# Response Action Outcome Completion Report for Medical Training Facility

**Westover Air Reserve Base  
Massachusetts**

**APPENDIX A RESPONSE TO COMMENTS ON THE DRAFT FINAL  
RESPONSE ACTION OUTCOME COMPLETION REPORT**

The following responses have been prepared to address AFCEE and Westover ARB comments made to the draft report. Each AFCEE and Westover ARB comment is shown below in italics with the corresponding response below each comment.

FIGURE 2.1

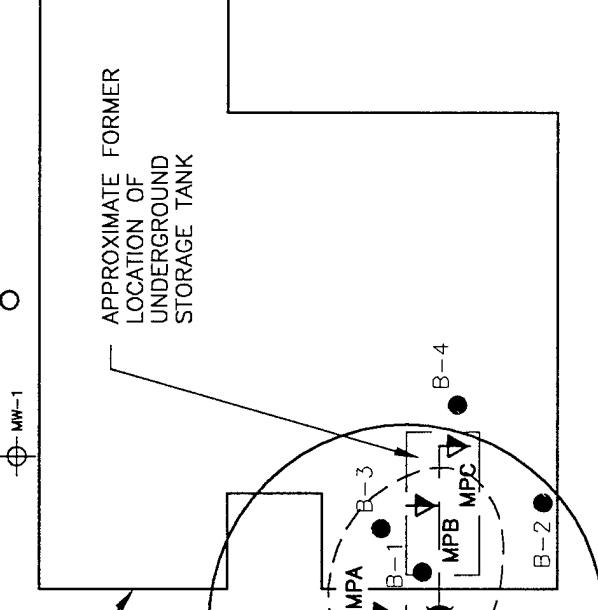
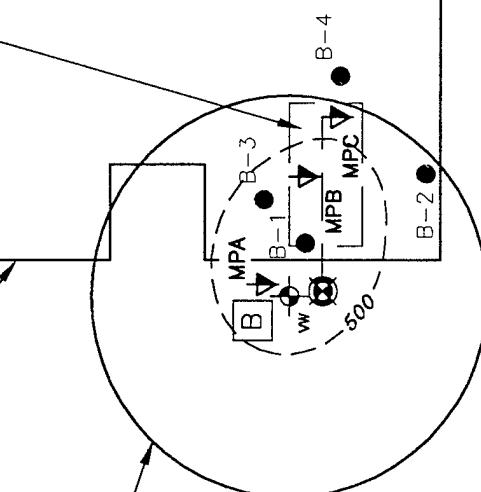
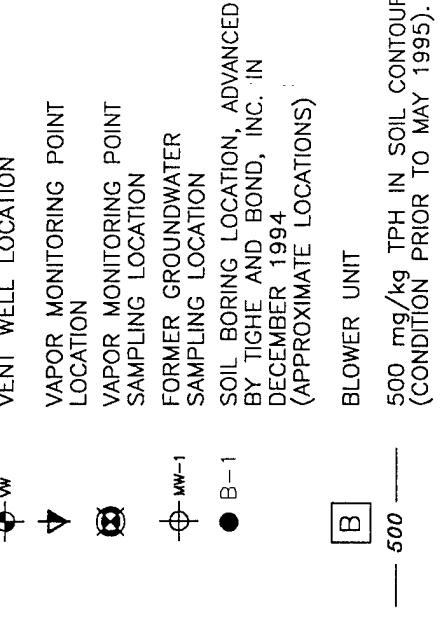
- 3) *Page 2-3, Figure 2.1. Show the approximate location of the groundwater sampling point that ECS did in 1994.*

Figure 2.1 has been revised to reflect this comment.

FIGURE 4.3

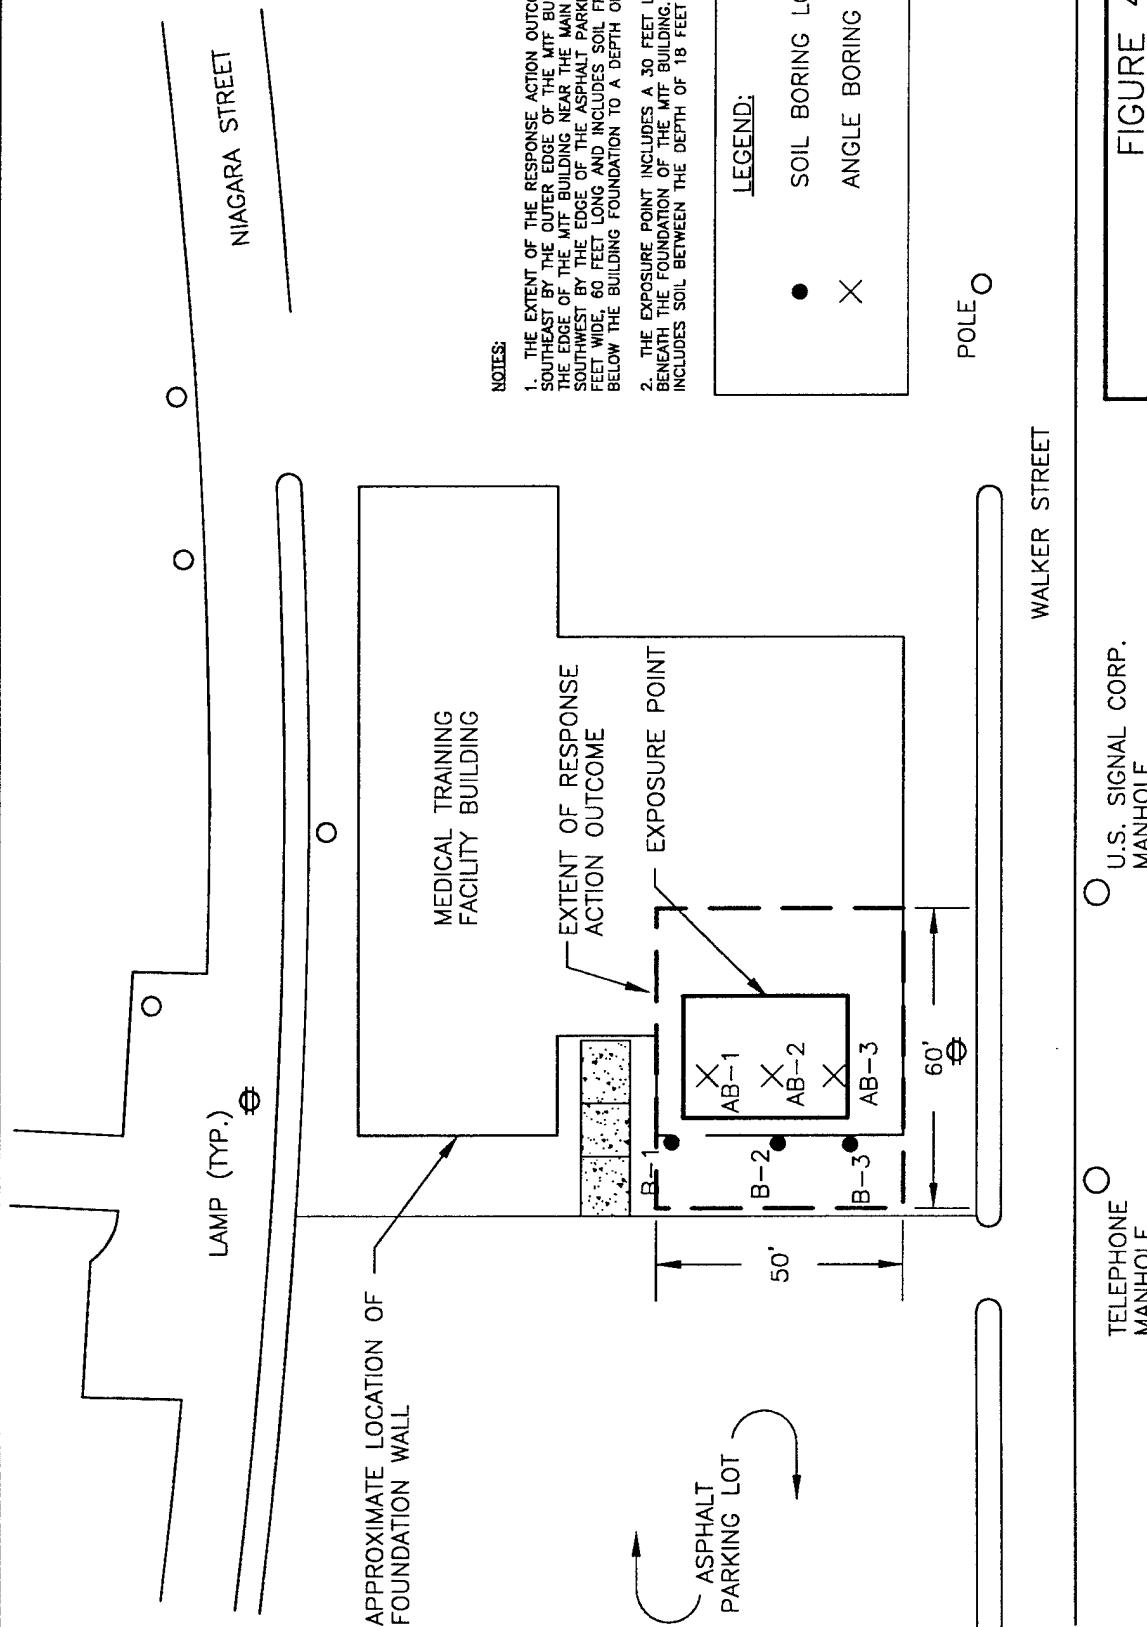
3. *The report did not contain a site map which documents the portion of the disposal site for which the RAO applies. The map should show dimensions from buildings, depth (horizontal and vertical depths of soil contamination), other benchmarks or surveyed property lines.*

A site map which documents the portion of the disposal site for which the RAO applies has been added to the report (Figure 4.3).

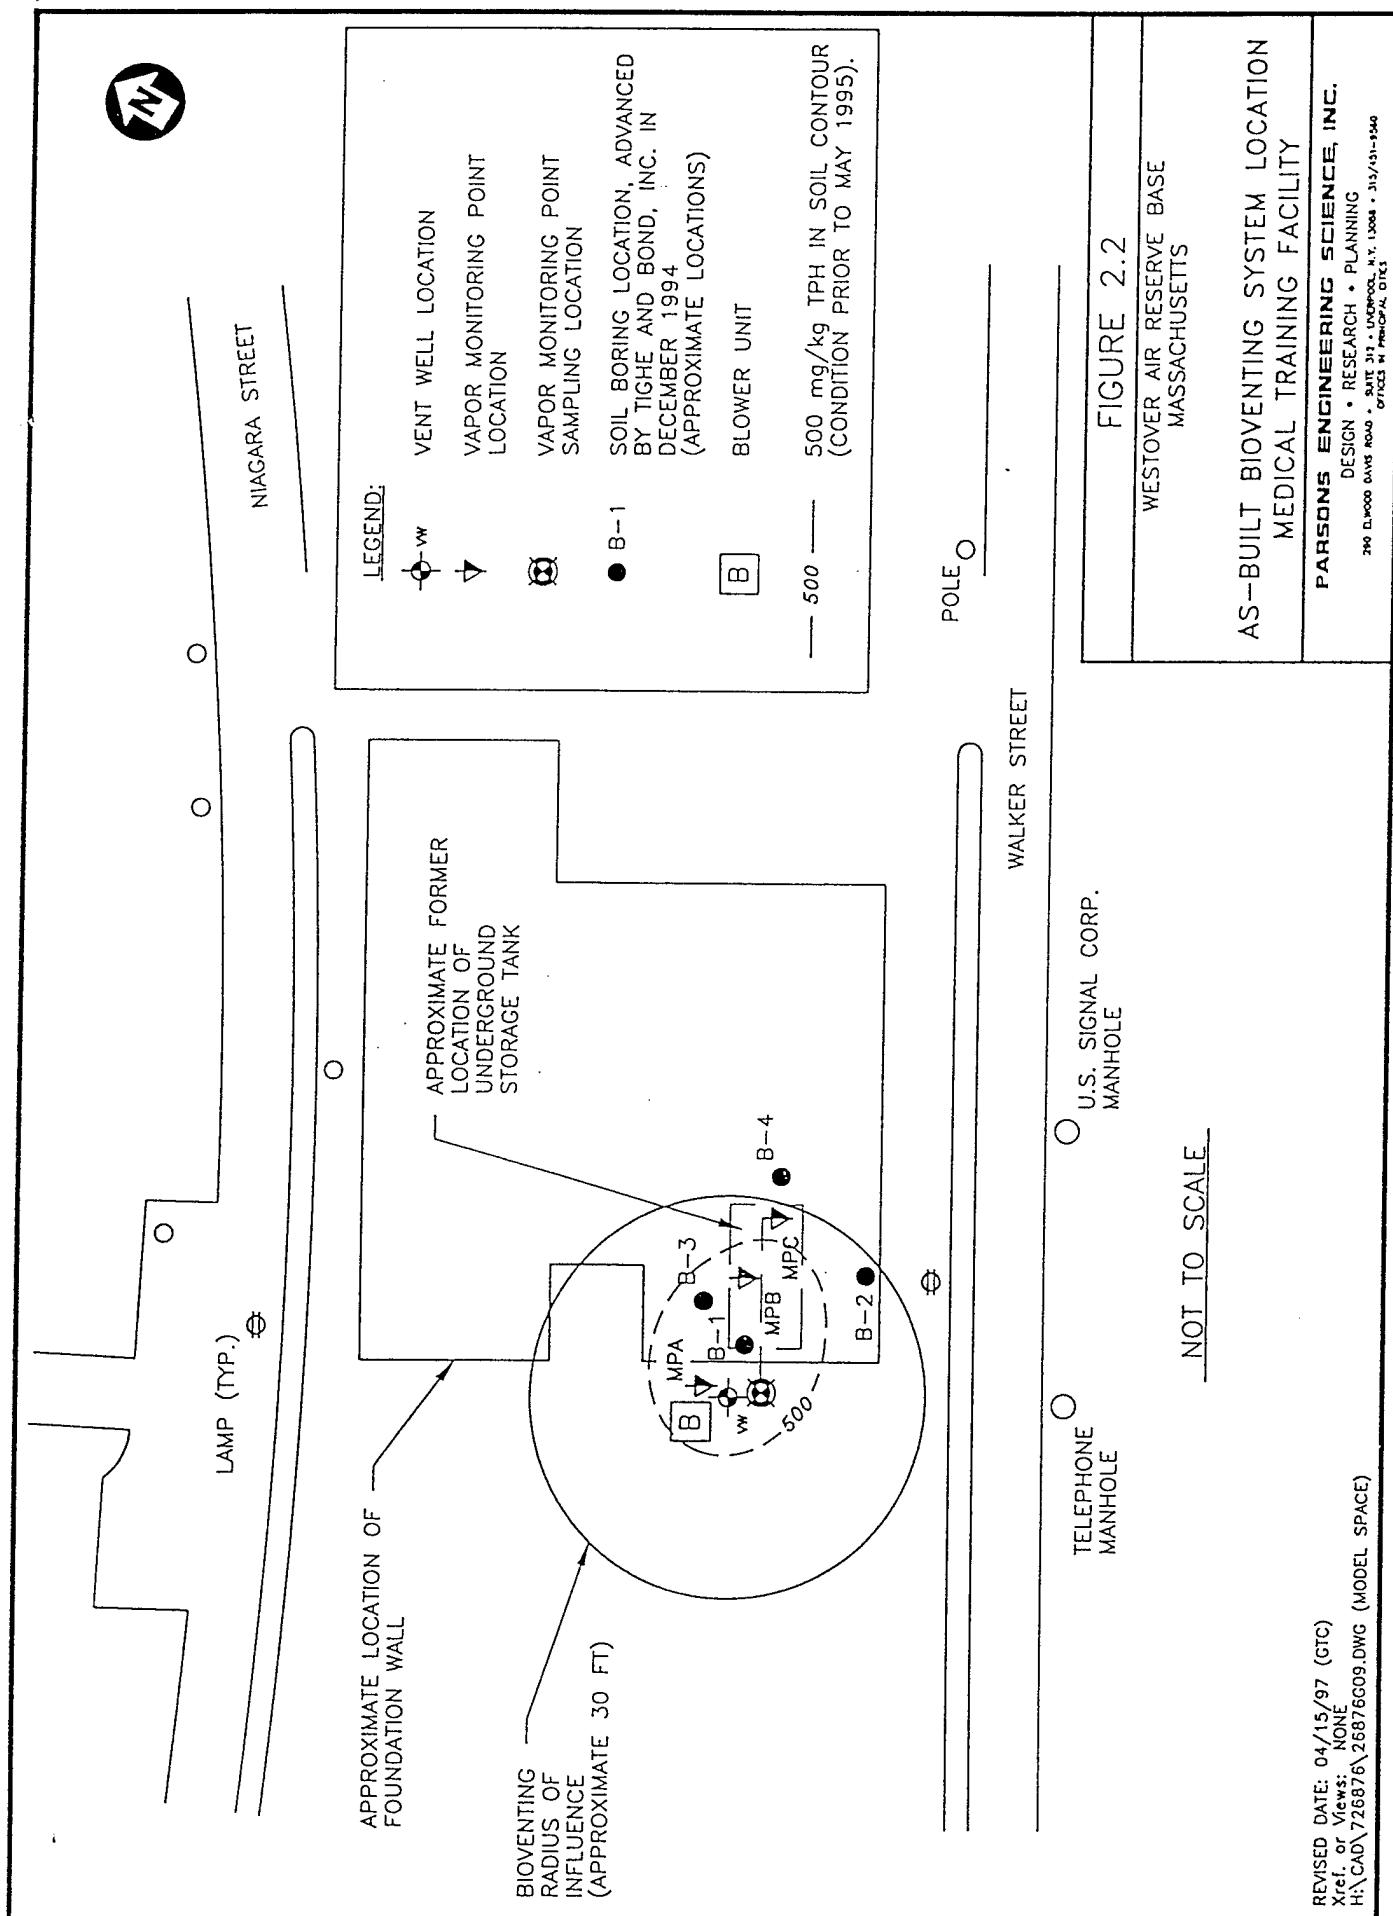
6. *As stated in the report, "the angled boreholes will be drilled at approximately a 45 degree angle, beginning 15 feet away from the building foundation." These boreholes will be completed to 30 feet below the ground surface, and 15 feet within the building foundation." On Figure 4-1 (soil sampling location) it appears that this will give you a sample at 15 feet under the foundation or in the middle of where the UST used to be located. How will the east (far) side of the*

The east end of the former UST area was sampled during an investigation by Tighe and Bond, Inc. in December 1994, location B-4 on Figure 2-2. This soil sample was collected from the 40 to 42 foot depth interval, was analyzed, and detected BTEX compounds below the method detection limit and TPH concentrations of less than 55 mg/kg. In addition, to further document the extent of contamination for the RAO, Parsons ES installed a soil vapor monitoring point (MPC) on the east end of the former UST location in April 1995. This location has shown low concentrations of field analyzed total volatile hydrocarbons (TVH) (less than 75 ppm). Therefore, Parsons ES excluded the collection and analysis of soil from this area because soil and soil gas samples have been collected from this area previously and the results showed low levels of contamination.

FIGURE 2.3

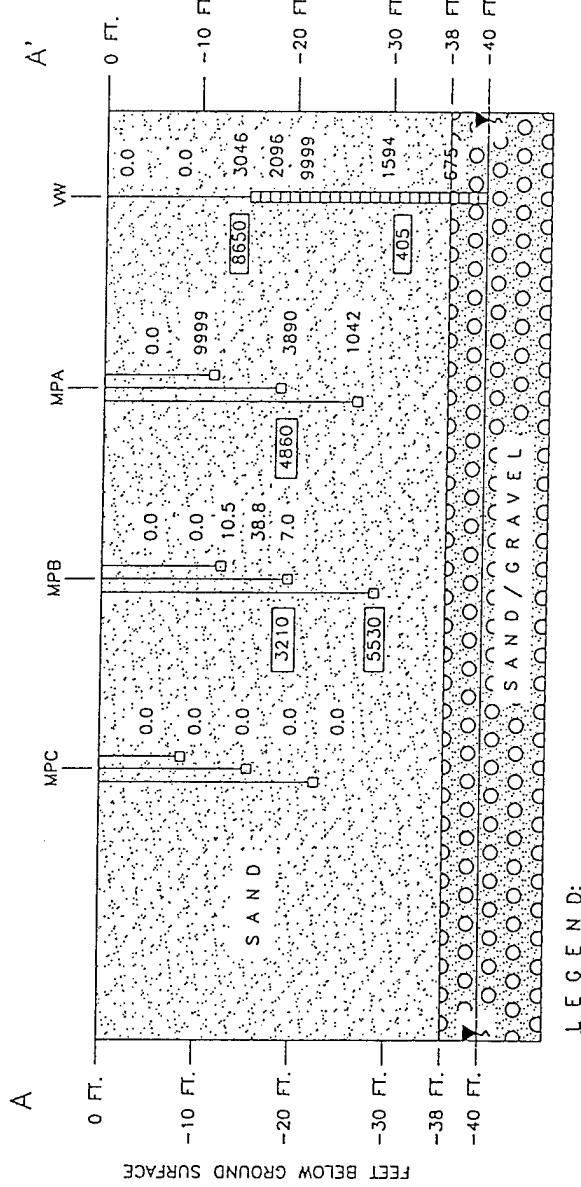
1. *Figure 2.3. All the following refer to the field and lab sample:*
  - a. *Indicate in the legend text that the lab data are gas samples*
  - b. *Are the lab data ppmv or ppm?*
  - c. *Please be consistent in upper/lower case. Field data is ppmv and lab data is PPM.*
  - a. The following change has been made to the legend on Figure 2.3; "soil gas field screening results" has been added to replace "field screening results" in the legend on Figure 2.3.
  - b. A note was added in the legend on Figure 2.3 that laboratory results are in milligrams per kilogram.
  - c. All upper case PPMs were changed to lower case.
